Subject: Duke Energy Carolinas, LLC
Oconee Nuclear Station, Units 1, 2, and 3
Docket Numbers 50-269, 50-270, and 50-287,
Renewed Operating Licenses DPR-38, DPR-47, and DPR-55
Licensing Basis for the Protected Service Water System - Responses to
Request for Additional Information

Responses to RAI Items

Figure 161.1

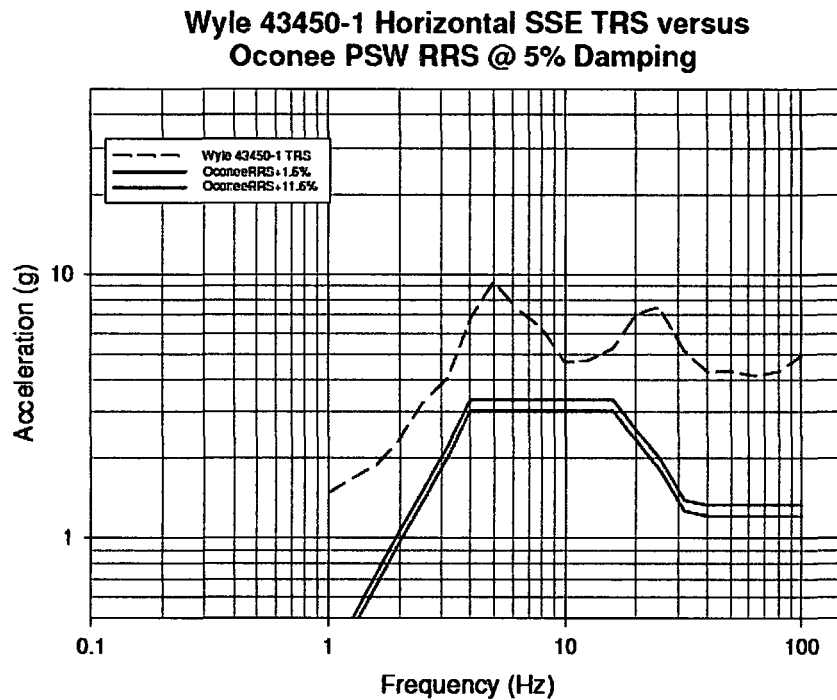
The in-structure response spectra for the PSW Battery Room were specified in Deviation 1 of OSS-0320.00-00-0023 Rev 1. C&D performed a comparison of the Test Response Spectrum (TRS) from the previous test in 43450-1 against this Required Response Spectrum (RRS), after adjusting for both the 10% margin required by IEEE 323-1974, and to account for a weight difference between the tested and supplied Batteries and Battery Racks. The TRS vs. RRS for the Safety Shutdown Earthquake (SSE) is shown in Figure 161.1 and Figure 161.2 (Note: Figures 161.1 and 161.2 provided in the RAI #161 supplemental information section of

Figure 161.2

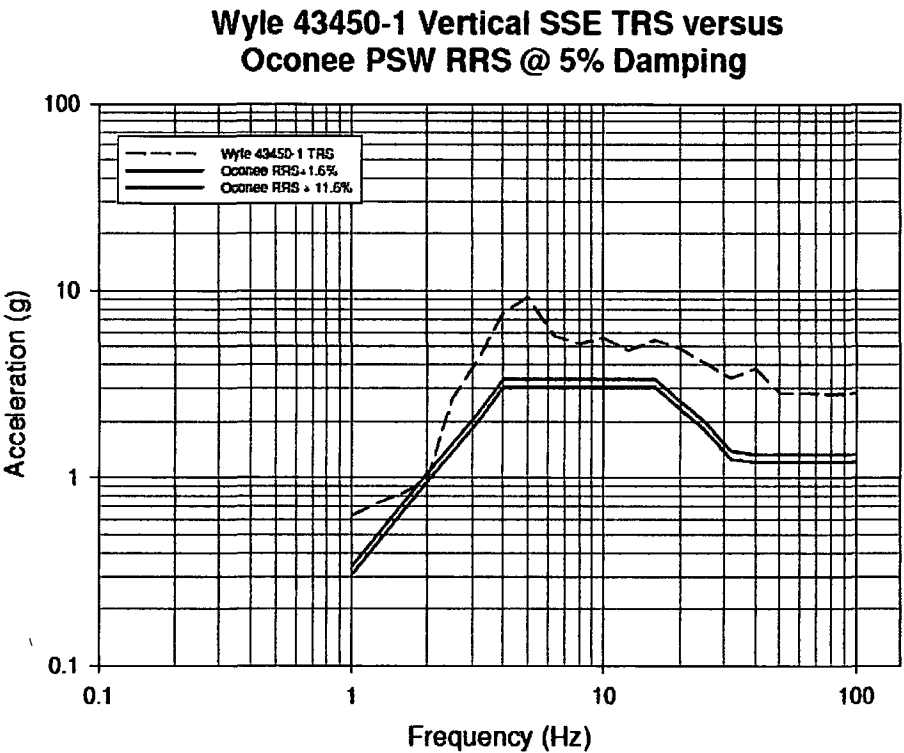
Attachment 1). The small excursion in Figure 161.2 where the TRS did not fully envelope the RRS is justified within QR-2312237 as being acceptable as the batteries and battery racks are not dynamically responsive at low frequency.
